ADDENDUM

NO. 1

PROJECT NAME: New Operations Building

PROJECT NUMBER: 1971-05-01

1 EQUIPMENT PLAN - LEVEL 1 - AREA B - OPERATIONS BUILDING
1/8" = 1'-0"

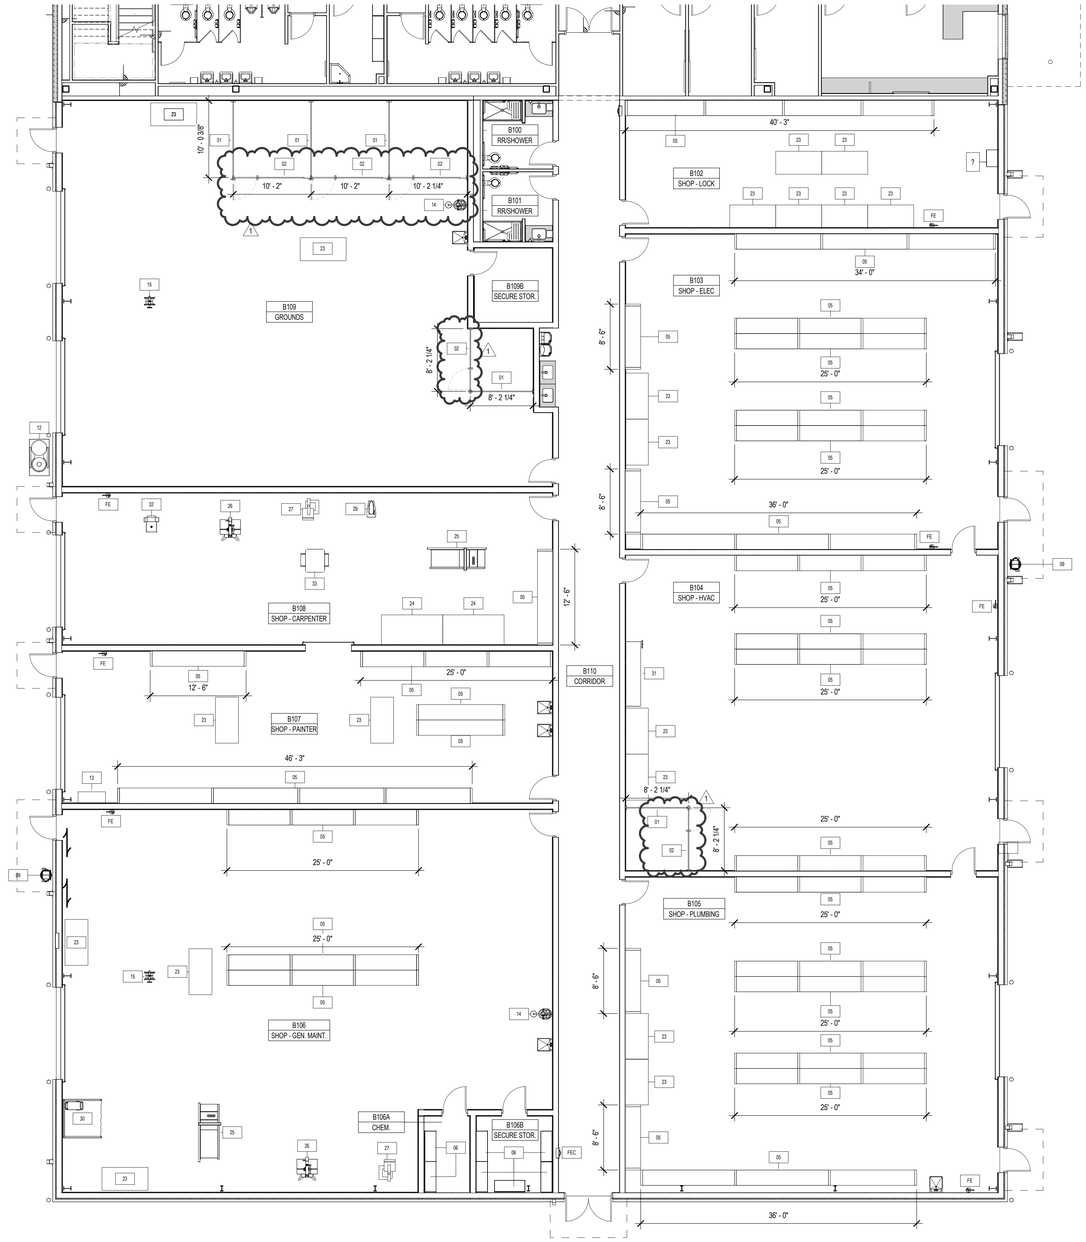
AD No 1, Arch. Item 49: To the Drawings, Sheet A8.03, "EQUIPMENT PLAN - LEVEL 1 - AREA B - OPERATIONS BUILDING,"

1 EQUIPMENT PLAN - LEVEL 1 - AREA D - WAREHOUSE
1/8" = 1'-0"

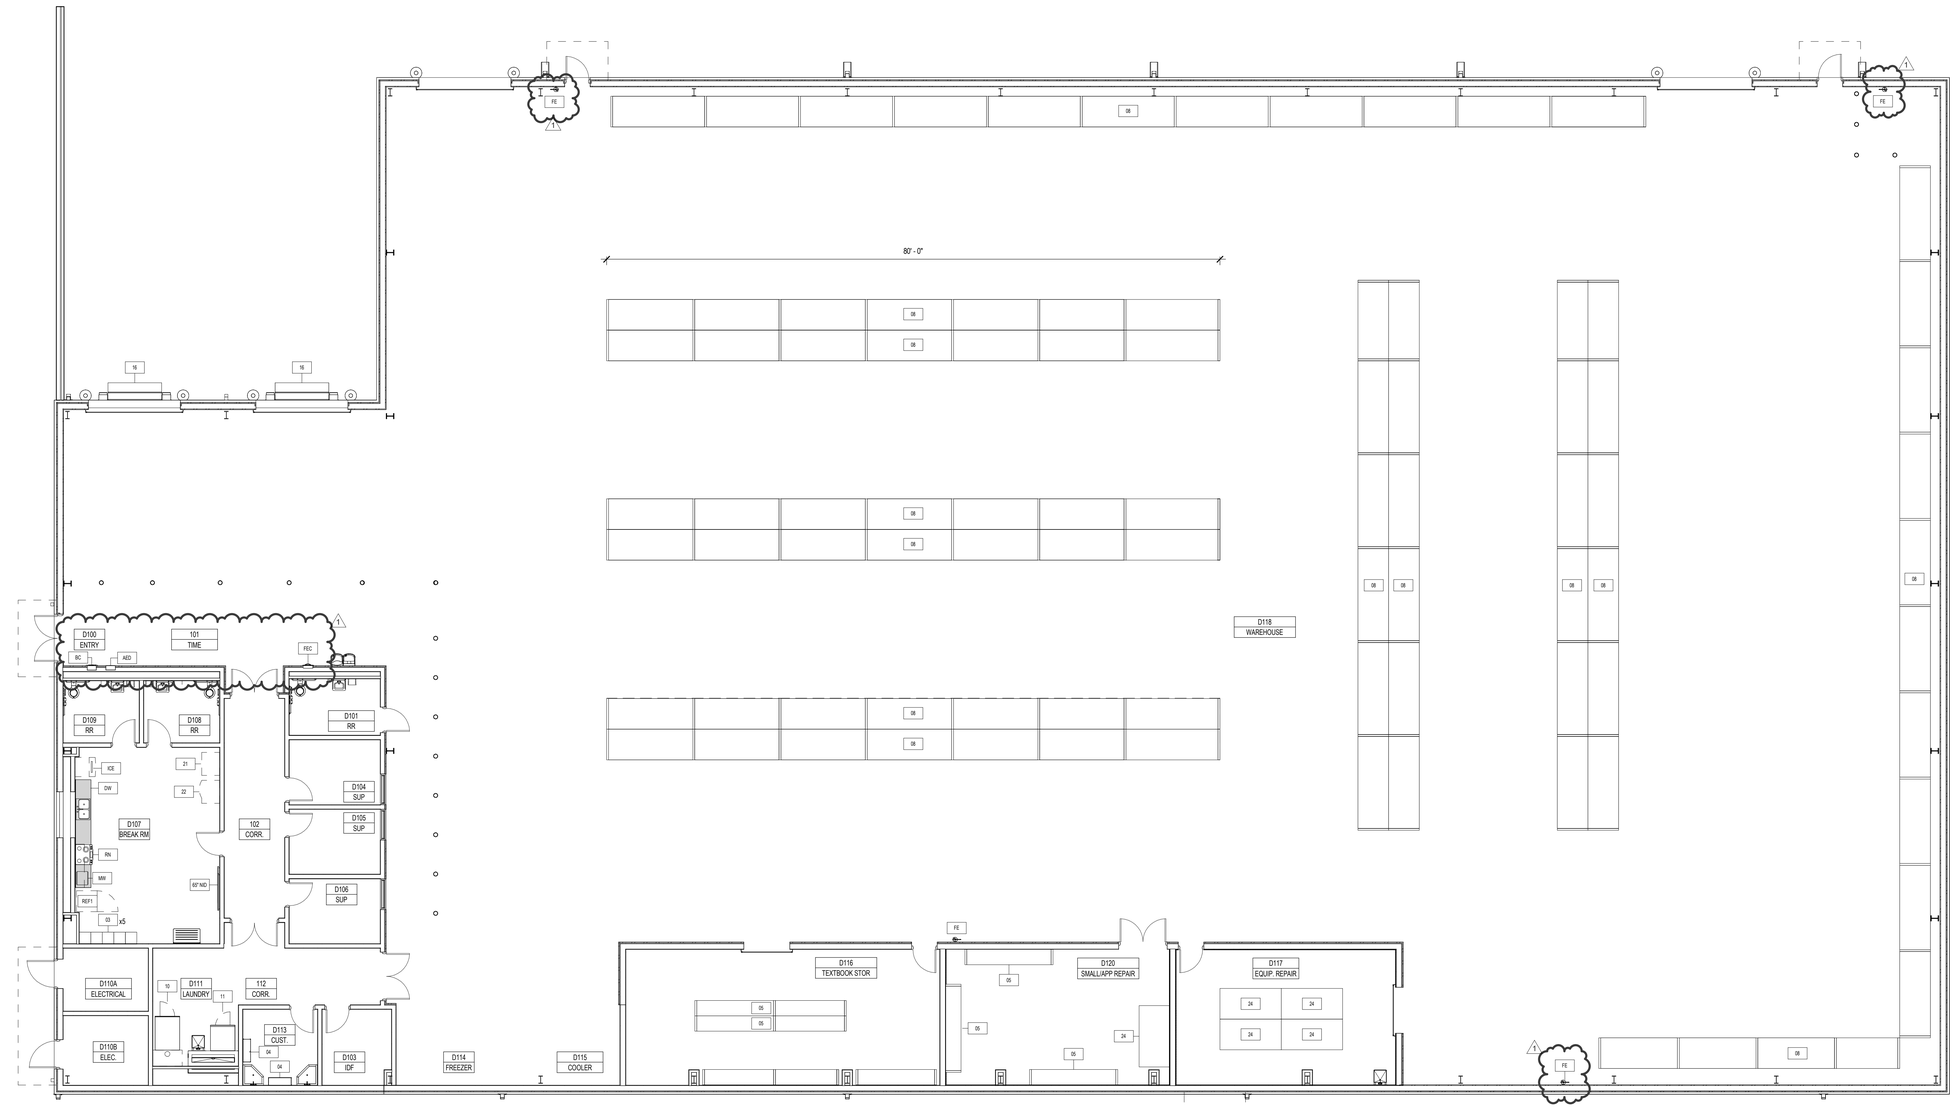
AD No 1, Arch. Item 50: To the Drawings, Sheet A8.04, "EQUIPMENT PLAN - LEVEL 1 - AREA D - WAREHOUSE,"

PACKAGE	VOLUME
Job No. 1971-05-01	Sheet No. P1.02
Drawn By: SCM/ZS	
Date: 09/18/2025

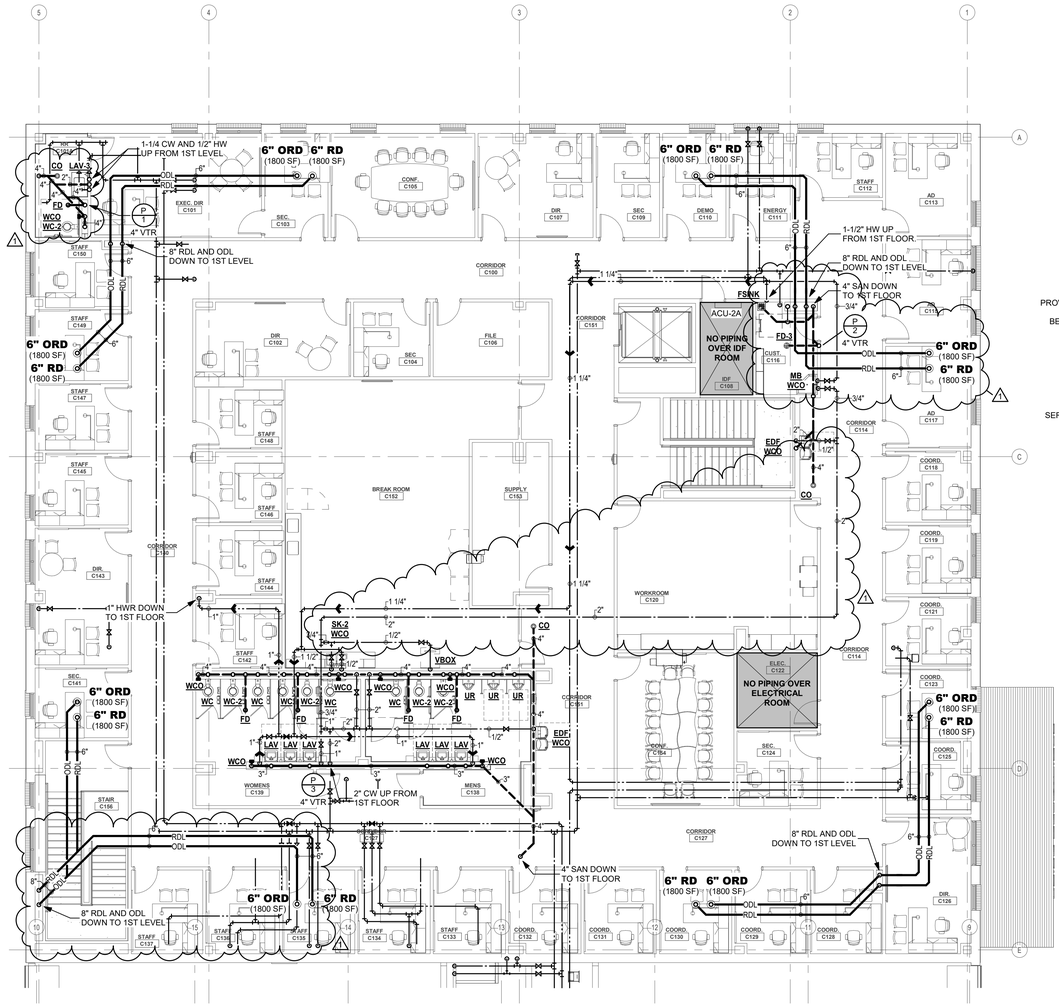
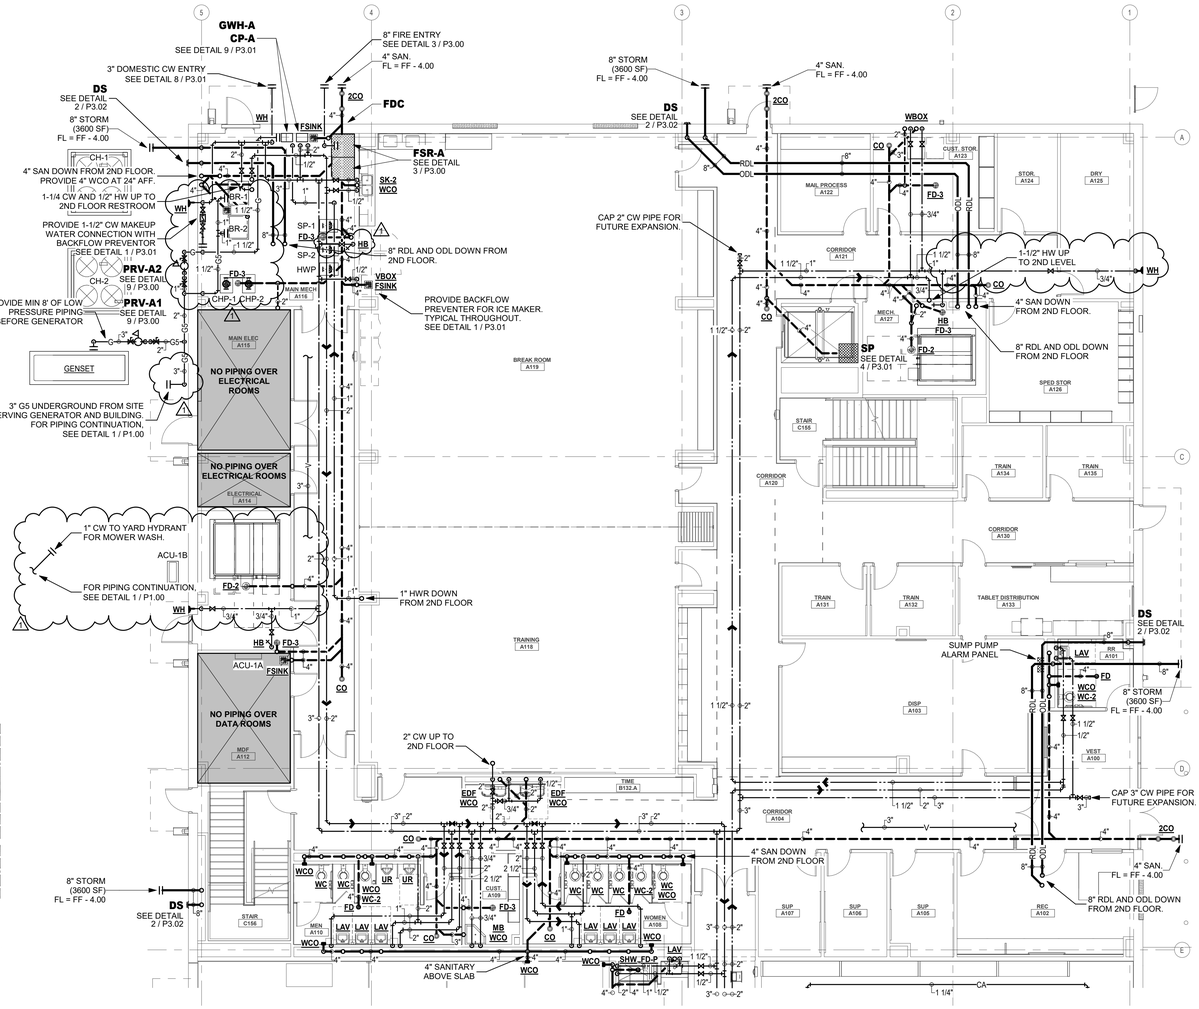
AD No 1, Plumb. Item 9: To the Drawings, Sheet P1.02, "PLUMBING FLOOR PLAN - LEVEL 1 / 2 - AREA A / C - OPERATIONS BUILDING,"

PACKAGE	VOLUME
Job No. 1971-05-01	Sheet No. P1.03
Drawn By: SCM/ZS	
Date: 09/18/2025

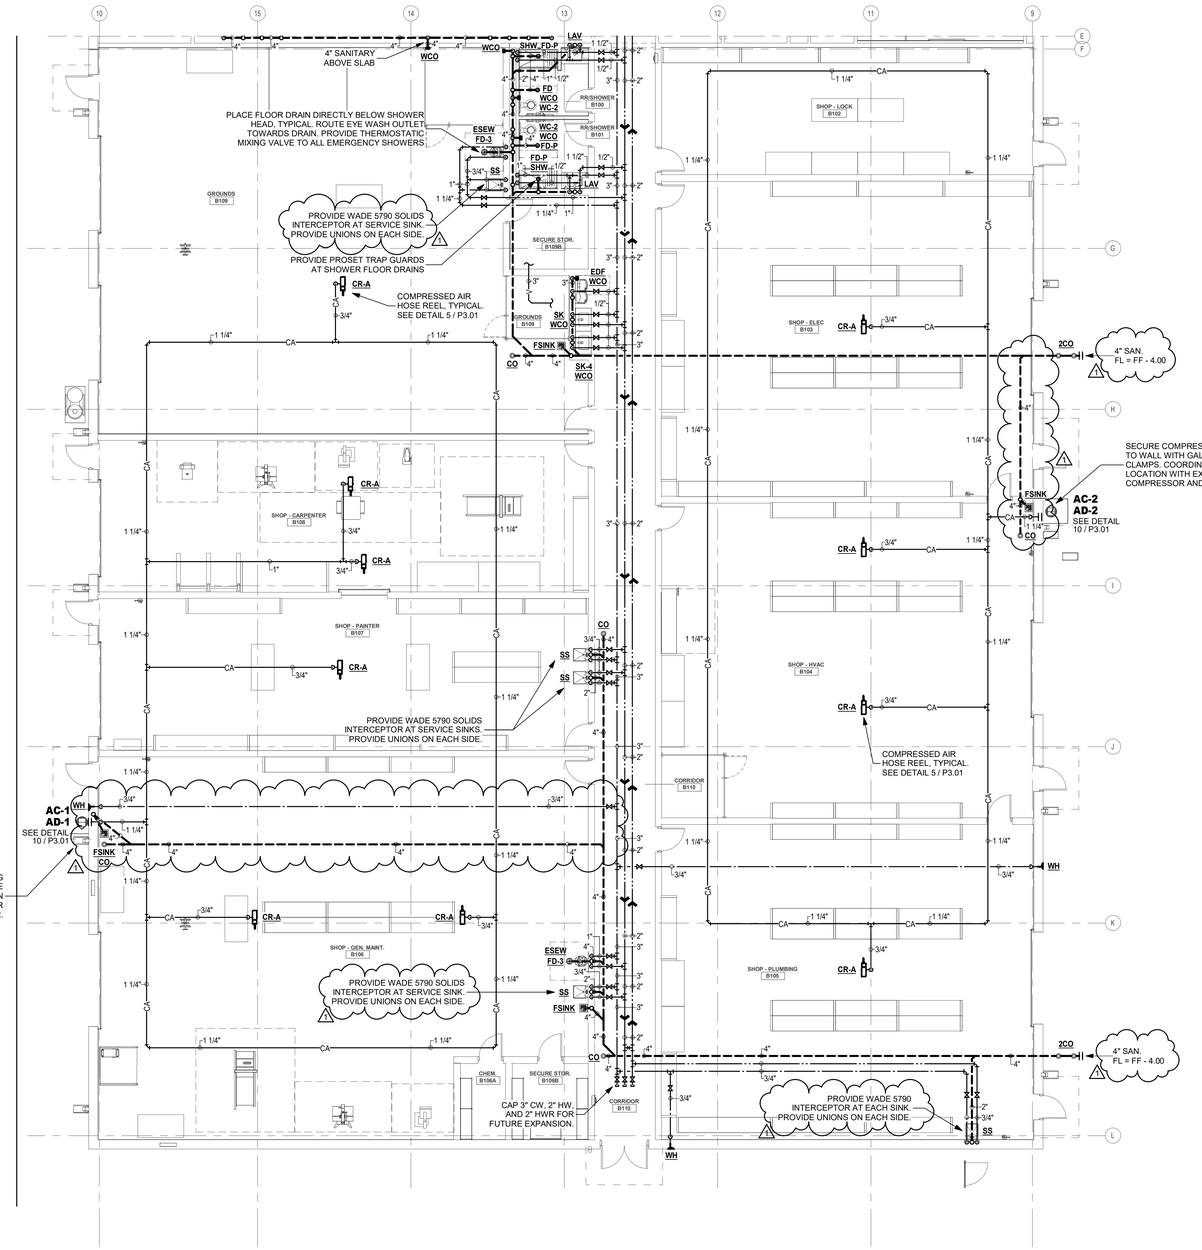
AD No 1, Plumb. Item 10: To the Drawings, Sheet P1.03, "PLUMBING FLOOR PLAN - LEVEL 1 - AREA B - OPERATIONS BUILDING,"

PACKAGE	VOLUME
Job No. 1971-05-01	Sheet No. P1.05
Drawn By: SCM/ZS	
Date: 09/18/2025

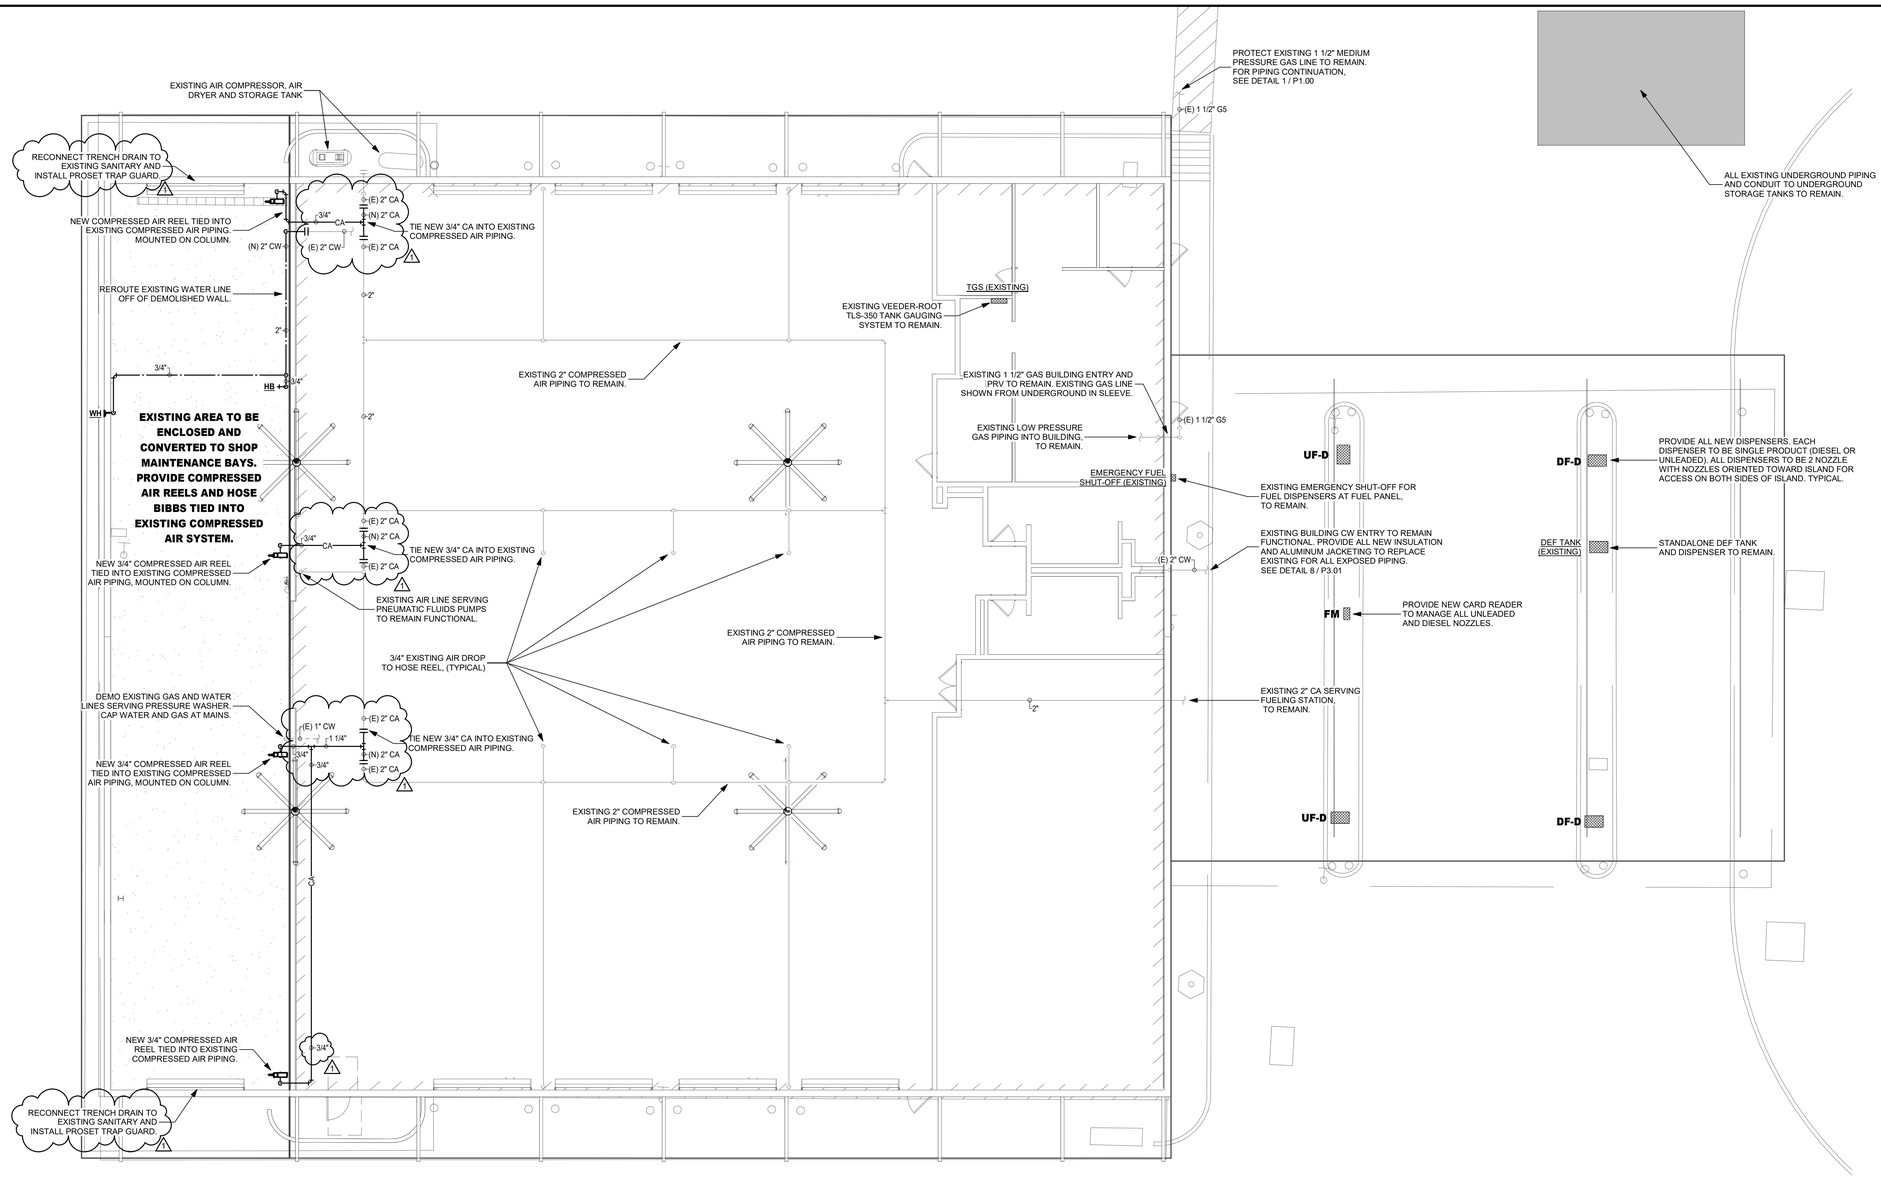
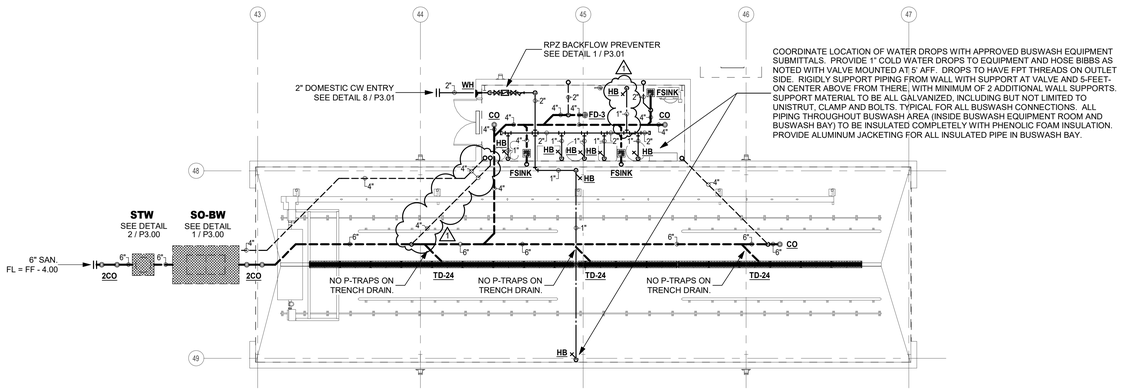
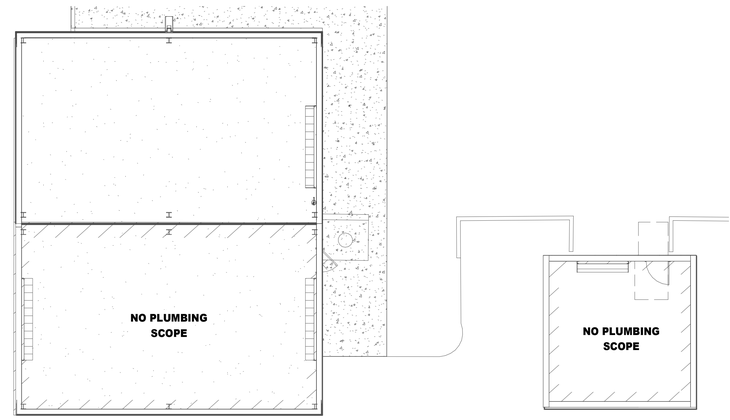
AD No 1, Plumb. Item 12: To the Drawings, Sheet P1.05, "PLUMBING FLOOR PLANS - BUS WASH, MECHANIC BAY, & STORAGE,"

PACKAGE	VOLUME
Job No. 1971-05-01	Sheet No. P4.01
Drawn By: SCM/ZS	
Date: 09/18/2025

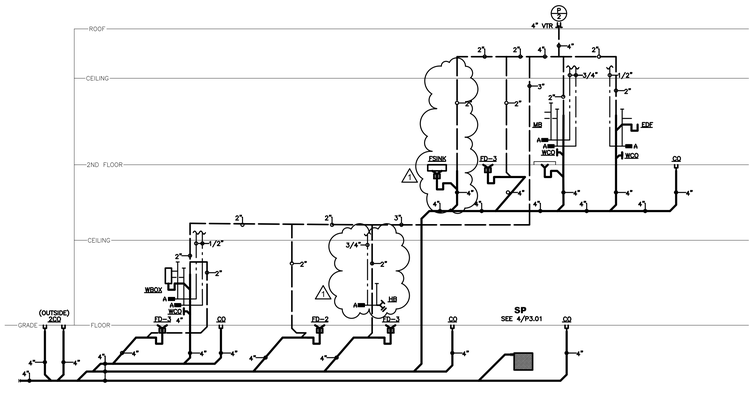
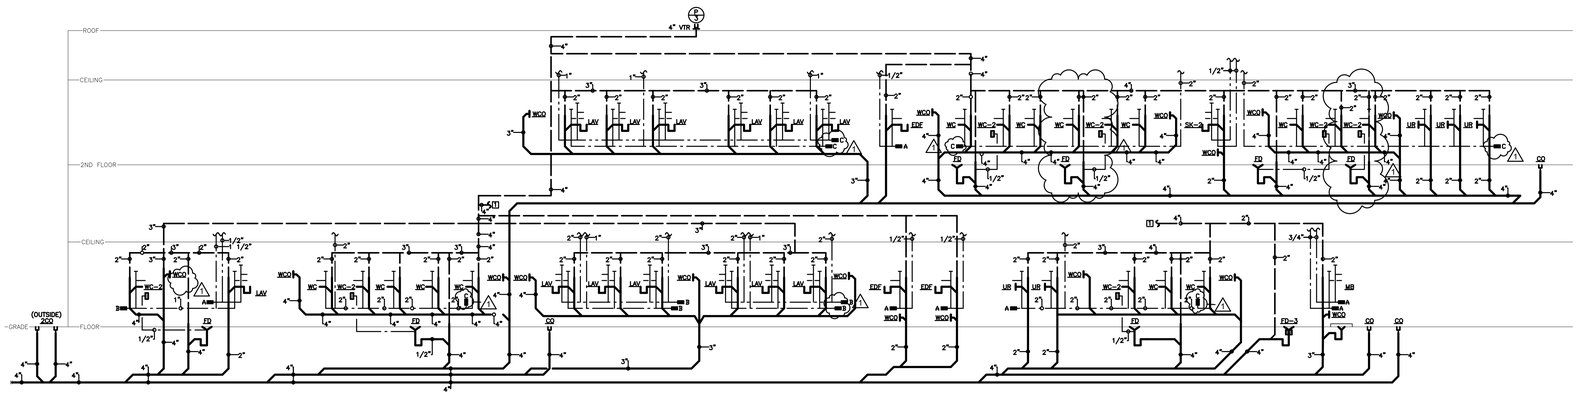
AD No 1, Plumb. Item 16: To the Drawings, Sheet P4.01, "PLUMBING RISER DIAGRAMS,"

AD No 1, Plumb. Item 17: To the Drawings, Sheet P4.01, "PLUMBING RISER DIAGRAMS,"
